Technical Bulletin

Aware: Harness Length & Pairing Feature

Aware Harness Length

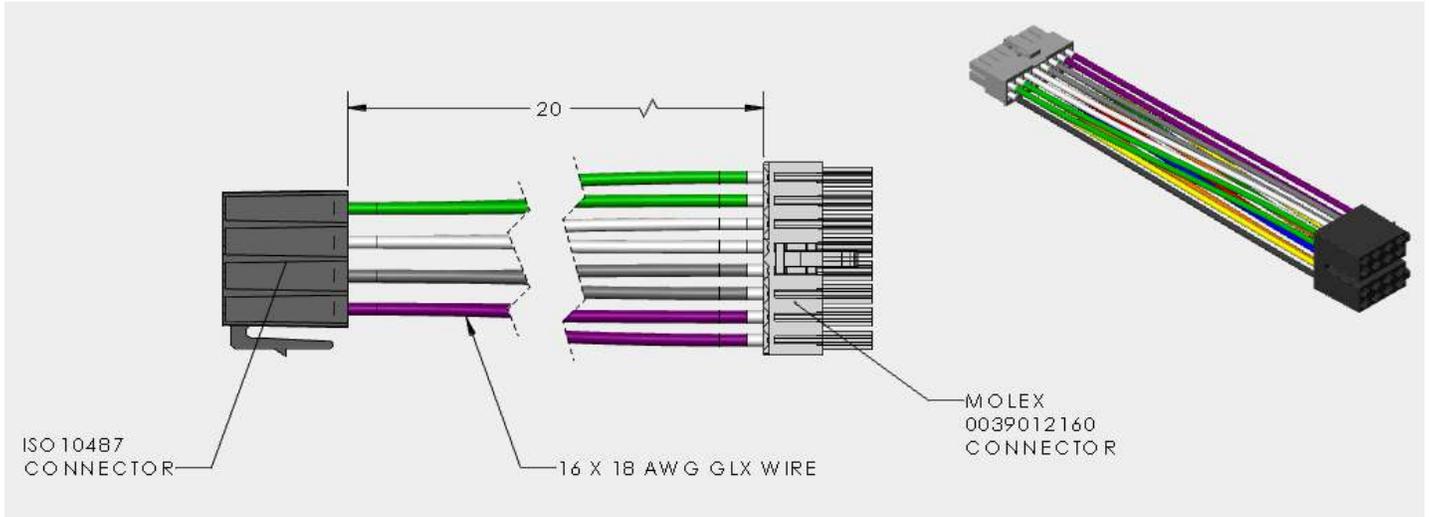
The Aware harness length has been changed from 6 inches to 20 inches in an effort to make installation of the product easier.
